BY: DEBRA D. CAMPBELL
Technical Data Plan
For Public Hearing:
2004-53

TD-1

SUBJECT: Administrative Approval for Petition No. 2004-53 by Citiline, LLC.

Rezoning Petition for:
Louisburg Square
Charlotte, NC

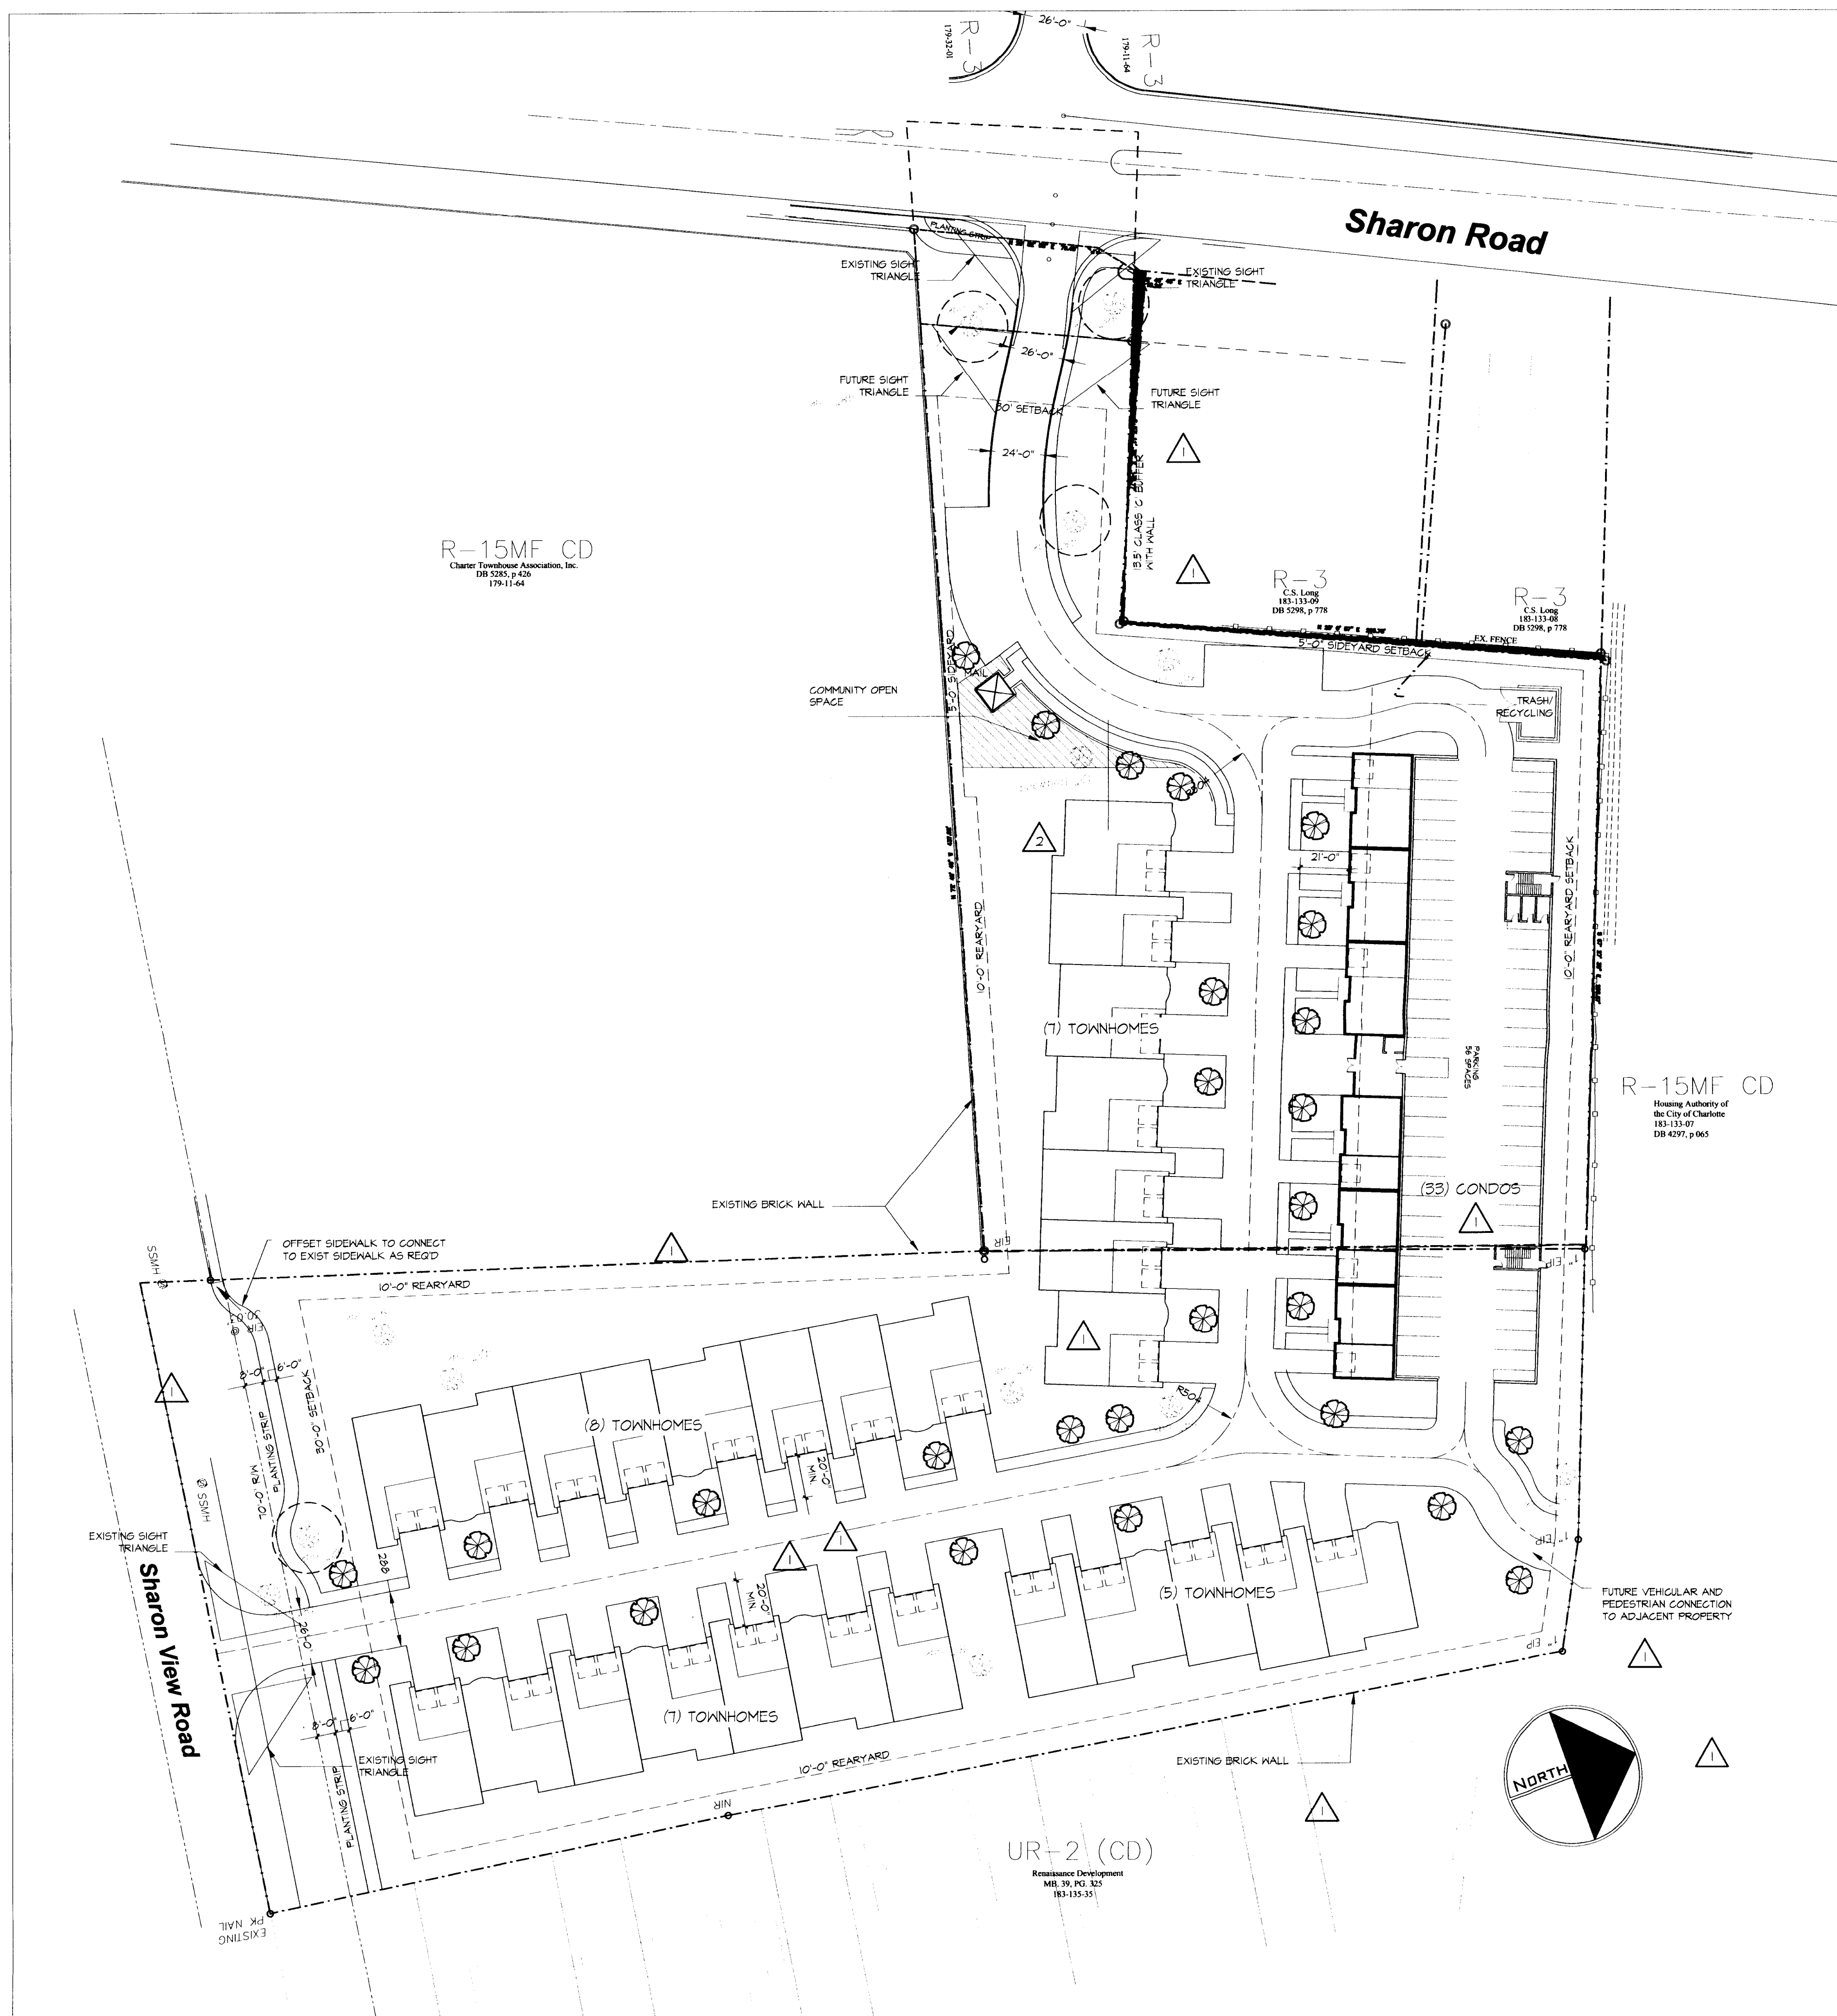
- The proposed for-sale project may be phased such that the first phase entrance for the private driveway may access either Sharon Road or Sharon View Road but no more than 47 units may be permitted for occupancy until the Sharon View Road connection is made. The street must align as closely as possible with Hazelton Road on the opposite side of Sharon Road. Petitioner may choose to connect the development's private street to tax parcels 183-133-09 and 183-133-08, at its discretion such that the uses are compatible as a mixed use or residential development, or if non-compatible users are restricted from entering the subject property. The subject project will allow a vehicular and pedestrian connection, with the exact location at petitioner's discretion, to parcel 183-133-07 once the project on the adjacent parcel is re-developed, such that the future uses of the adjacent parcel are compatible and there is a direct vehicular connection to Sharon Road from parcel 183-133-07 and an indirect vehicular connection to Savings Place Lane. Such future connection and easements will be written into the homeowner's association for the subject project such that the future association must be given the right to determine, at its discretion, how best to manage its own private street and property, if a future connection is made. If no vehicular connection is possible, the pedestrian connection will still be made once the property is redeveloped. Should petitioner construct a wall along the portion of the property abutting parcel 183-133-07, the portion of the wall where a future connection and easement will occur shall be built in a condition allowing feasible future connection. Seller agrees to disclose to home buyers of the future connections. No connection to either adjacent parcel 179-011-64 (The Charters) or 183-135-35 (Park Phillips) shall be practically possible or permissible due to adjacent ownership positions, currently.

Attached are copies of the revised plan (sheet TD-1) for the above rezoning petition. The plan has been revised to change the phasing. Since this change does not alter the intent of the development and is minor, I am administratively approving this revised plan. Please use this revised plan when evaluating requests for building permits and certificates of occupancy.
Note that the concepts renderings sheet attached to the original approval still applies.

TD-1

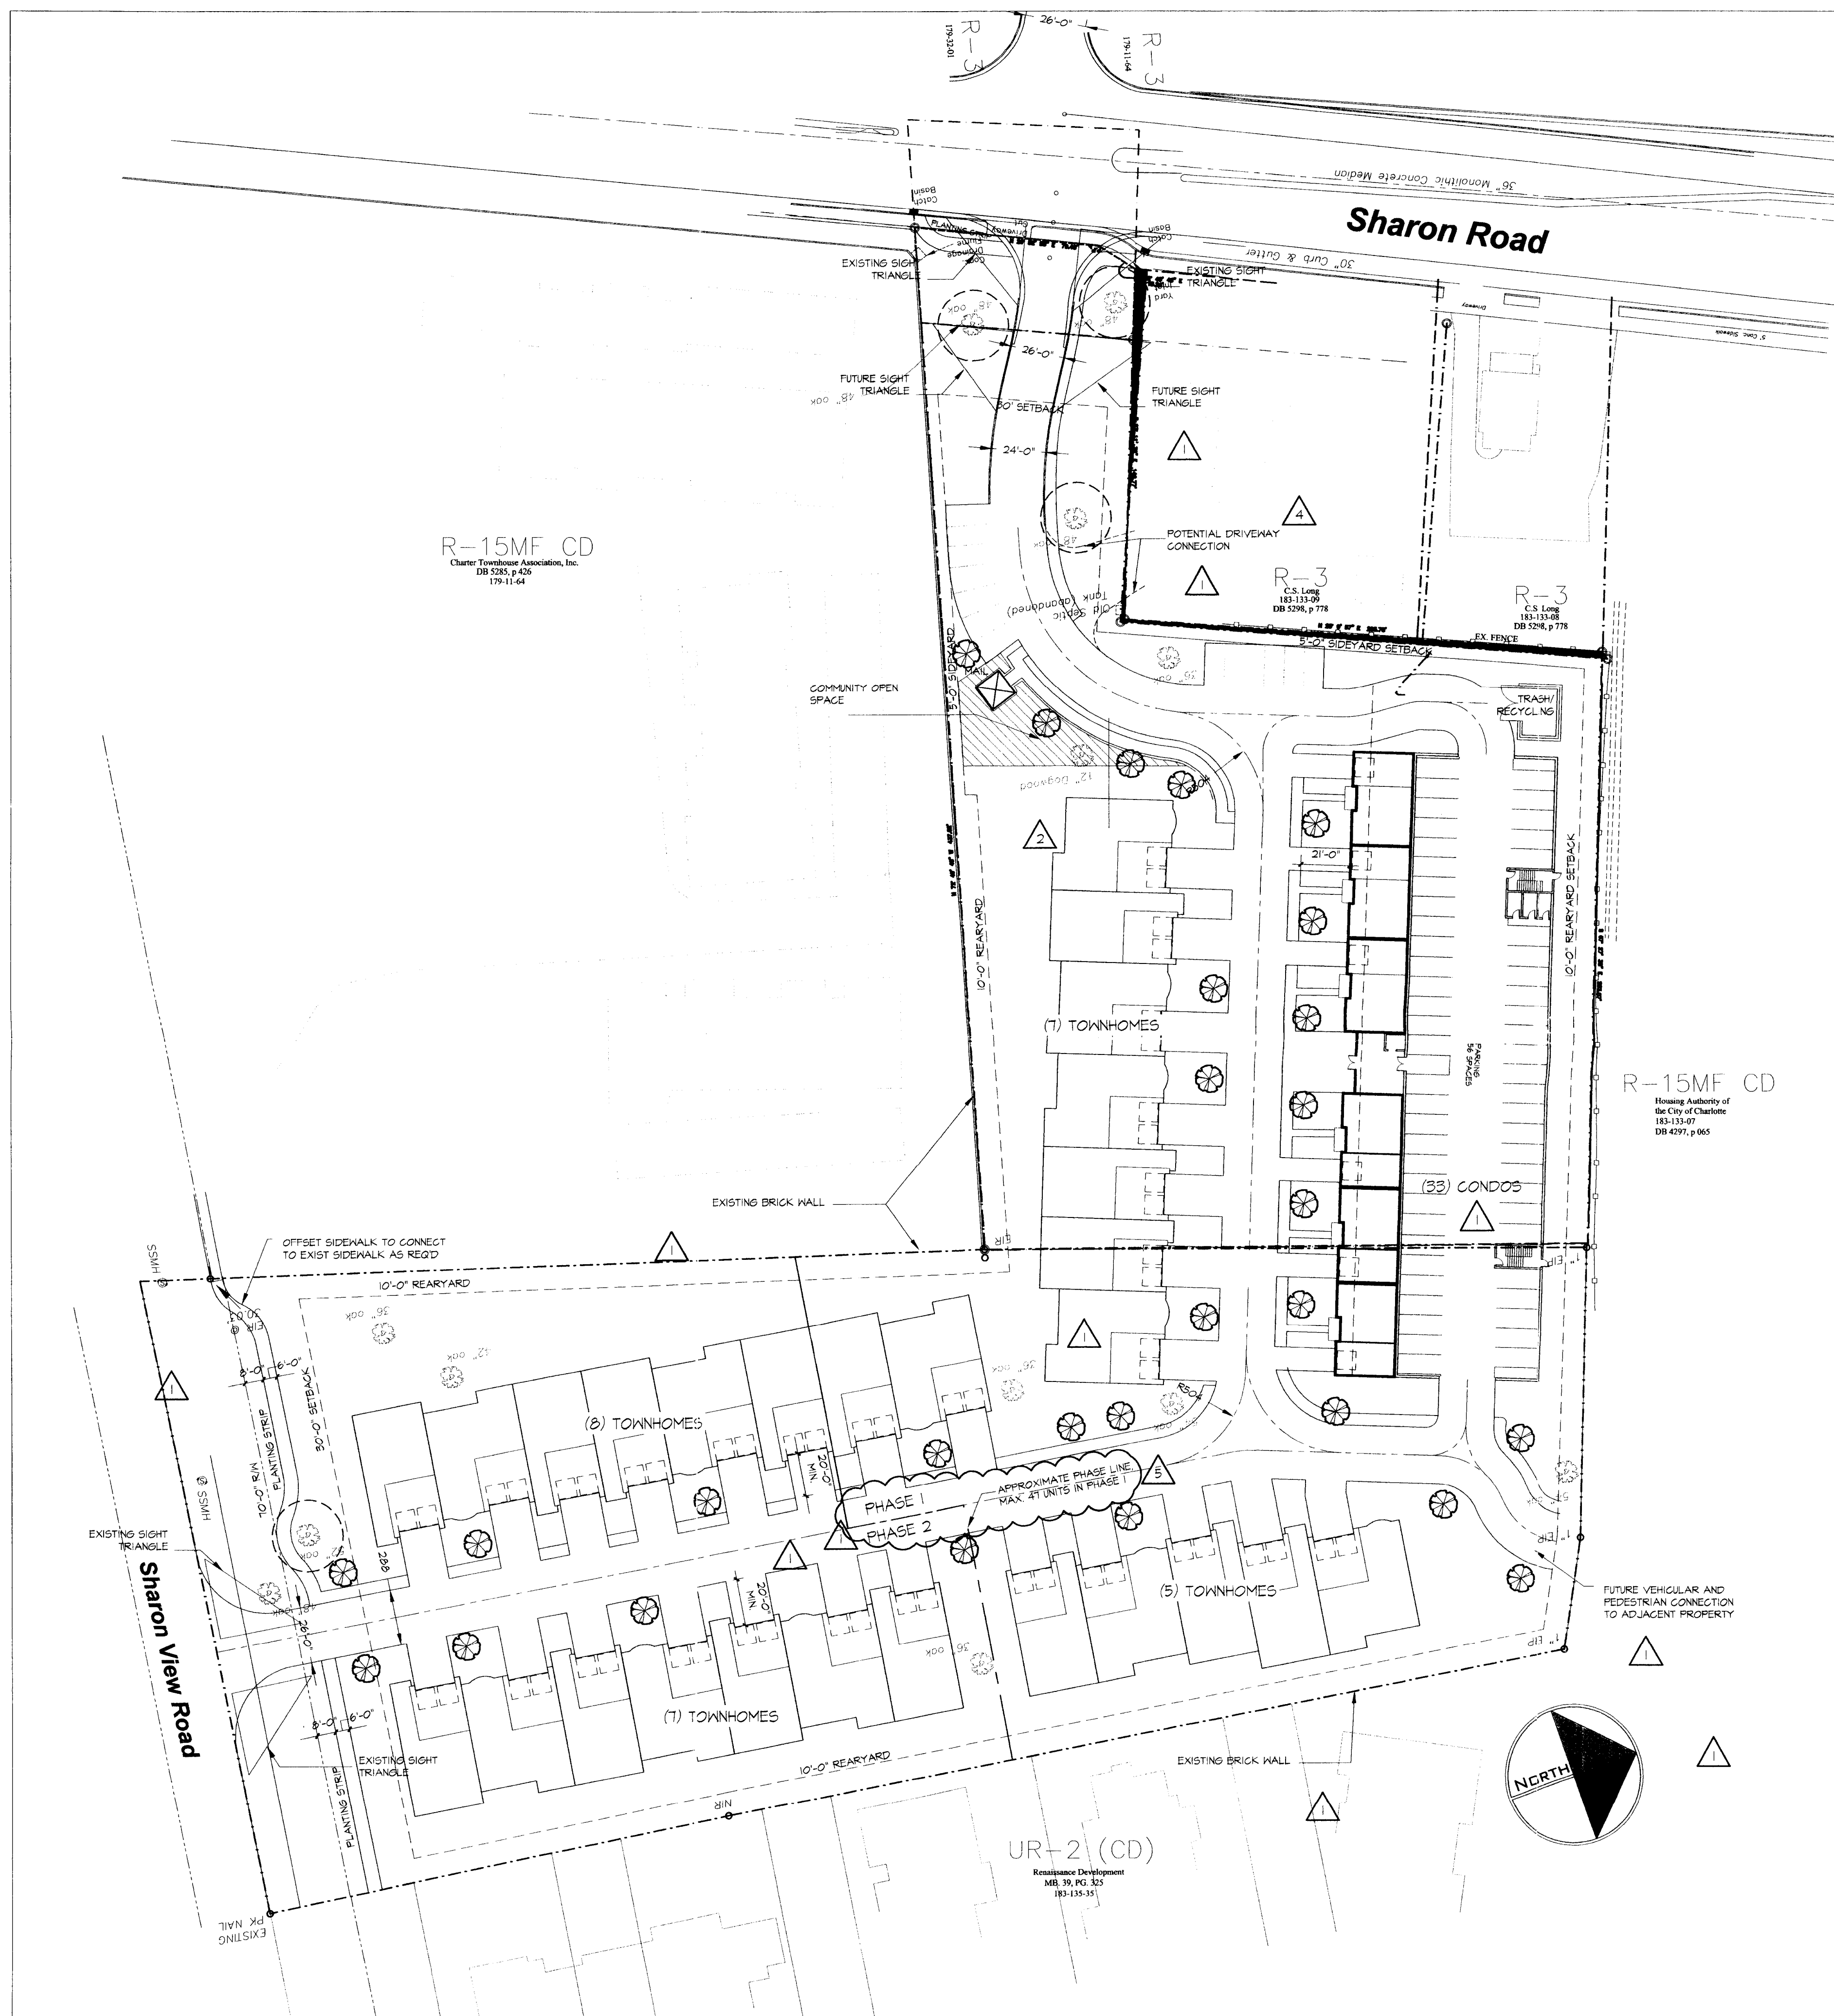
- The refuse location may vary but must be enclosed on three sides with a brick wall and a gate.
- Potential driveway connection subject to mutual agreement between adjacent landowners. (Reference rezoning application number 2004-94 for adjacent property.)

Attached is a copy of the revised plan (sheet TD-1) for the above rezoning petition. The plan has been revised to remove the buffer and wall and show a possible future connection to tax parcel 183-133-09. Since these changes do not alter the intent of the development and are minor, I am administratively approving this revised plan. Please use this revised plan when evaluating requests for building permits and certificates of occupancy. Note that the concepts renderings sheet attached to the original approval still applies.
